To: Files  
From: Nobu Toge  
Subject: Minutes of the CCB Hearing on RTML CCR (CCR#23) Cost Implications

Date: Friday, 2006/12/15

To: Proponents for CCR#23 (single IR, push/pull) and CCB Files  
From: CCB  
Subject: Question / Worksheet for CCR#23

J.Jaros scheme

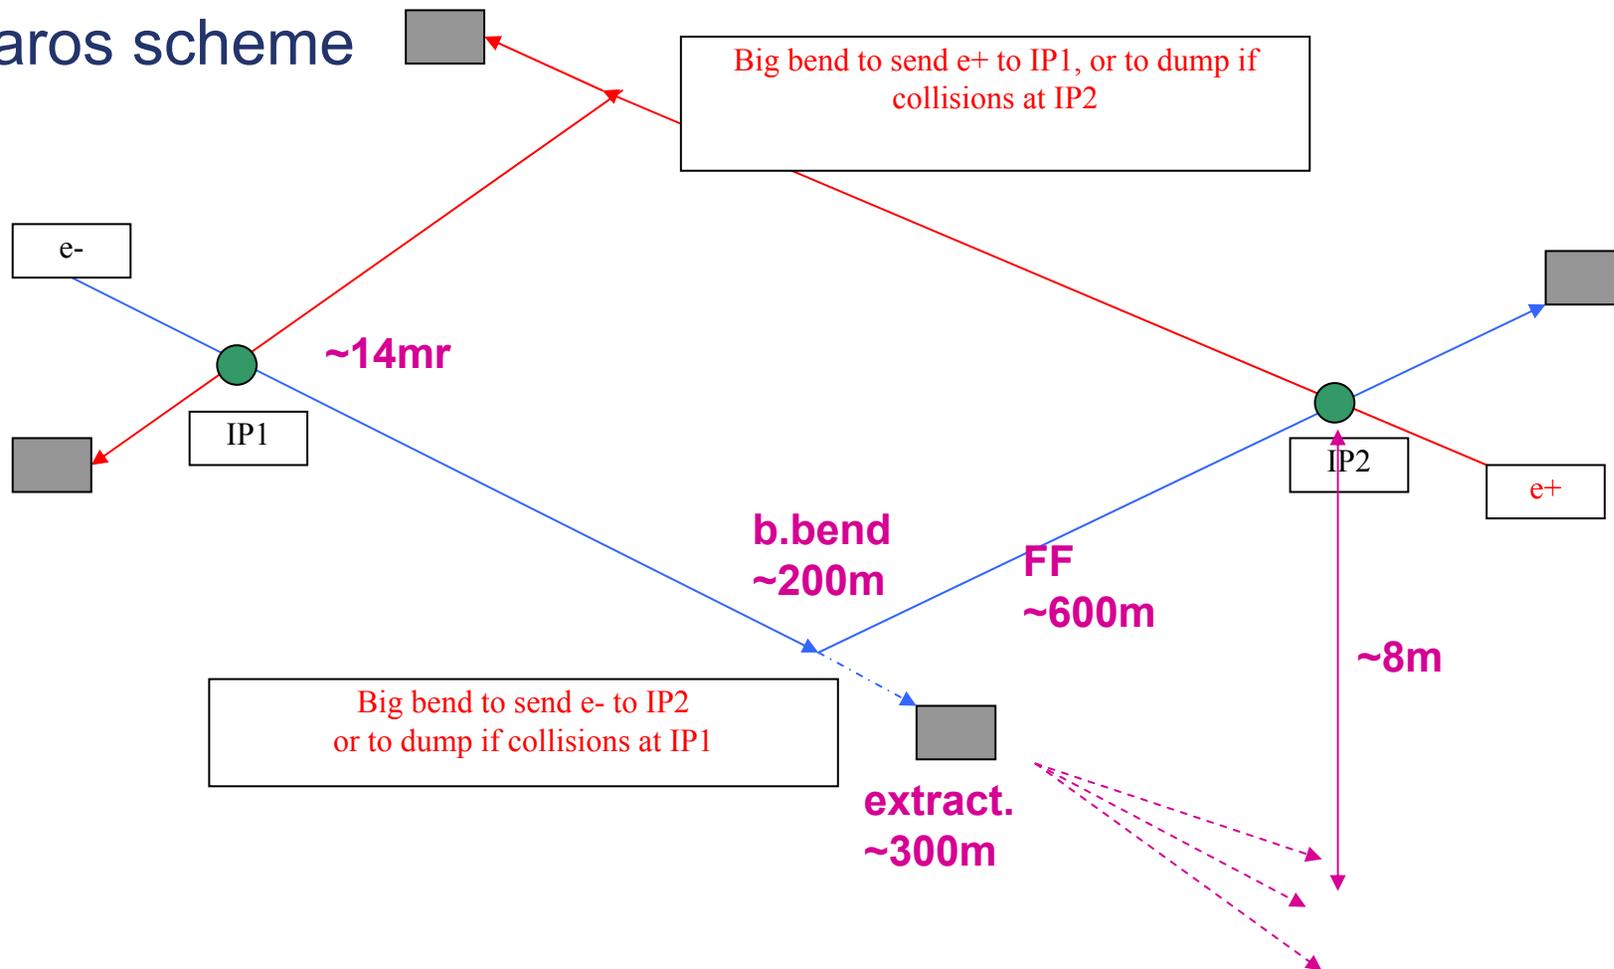
- There has been at least one suggestion (from J.Jaros) of a geometry based on two fixed detectors, a BDS that uses “90%” of its length to service them both, and a post IP big bend to the other IP. Disrupted beam from one IP (IP1) is dumped and not sent to the 2nd IP (IP2). If IP2 is happens to be the designated interaction point at that time, the beam will pass through IP1 without being focused, and so on. Is there any other solution? It is clear that the concepts definitely prefer stable conditions and are acquiescing to this CR (to the extent that they are) under duress. See a simple cartoon below. Any comments?*

- Collimation and/or diagnostics outside, FF has to be inside, after big bend => scale large, ~1km between IPs
- Two more dumps
- Muons from dump go through detector
- Both detector see beam always (cannot access one detector while other is taking data)
- All beamlines have big bend – limit of energy reach
- Big bend aperture need to accommodate ~1mr beamstrahlung photon cone (~0.5m aperture!) => high power consumption. Or intermediate photon collimator/dumps
- Detector solenoid field before FF couples the beam
- May require larger vertex radius
- Crab kick need to be separate for IP1 & IP2, require complicated compensation

- With these issues, the scheme neither viable nor cheaper
